## **BCA ASSESSMENT REPORT**

### **PORT BOTANY INDUSTRIAL ESTATE**

**PREPARED FOR:**  
**GOODMAN PROPERTY SERVICES**  
**(AUST) PTY LTD**

Revision 04

**Figure 2 - Areas of Non-Compliant Perimeter Vehicular Access per BCA C2.4.**

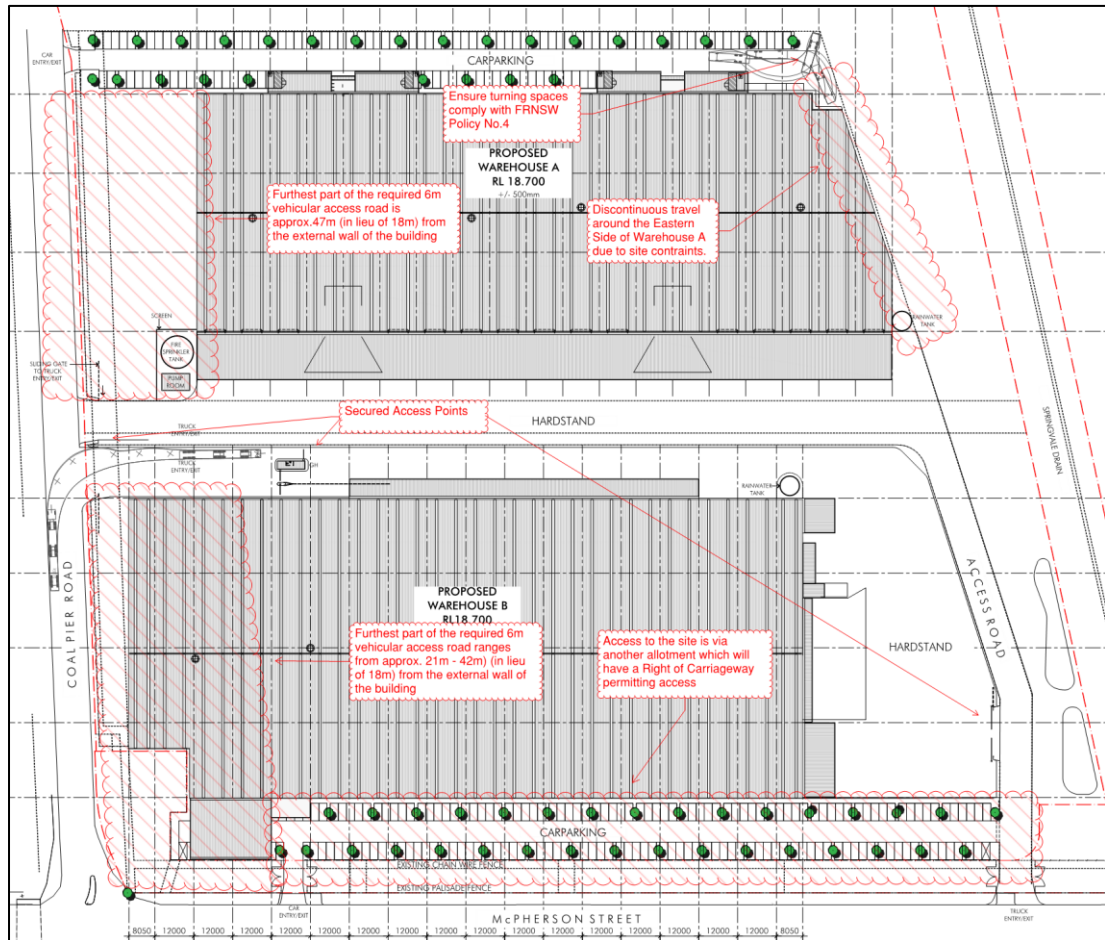
*Comments:* The perimeter access roads and turning bays will generally be designed to comply with the BCA and Fire & Rescue Guidelines (Policy No.4) however a few departures have been identified as matters requiring further attention by the project Fire Safety Engineer.

1. Vehicular Access will only be provided around three (3) sides of the building and is therefore discontinuous along the Eastern side due to site constraints associate with the Flood Storage Areas on the site. Suitable turning provisions will however be available along the Southern and Northern sides to facilitate brigade operations.
2. Additionally, the Western side will have the furthest part of the required 6m access road located at distances greater than 18m from the external walls of the building (approx.47m).

3. Vehicular Access will be provided around all four (4) sides of the building however the Western & South-Western side will have the furthest part of the required 6m access road located at distances greater than 18m from the external walls of the building (distances ranging between 21m and 42m).
4. Additionally, access to the site from McPherson Street necessitates brigade vehicles crossing via a separate allotment which will have a Right of Carriageway.

5. Access to the site will be controlled access and there will be secured access entrances, gates at the main entrance and guard / gate houses that will need to be considered.

*Alternative Solution:* The following non-compliance issues are required to be addressed as an Alternative Solution by the Fire Safety Engineer - refer to the numbered points below and the diagram over page for details of the proposed non-compliance issues:

**Note:** The above non-compliance issues are required to be addressed as an Alternative Solution by the Fire Safety Engineer to demonstrate compliance with Performance Requirements CP9.
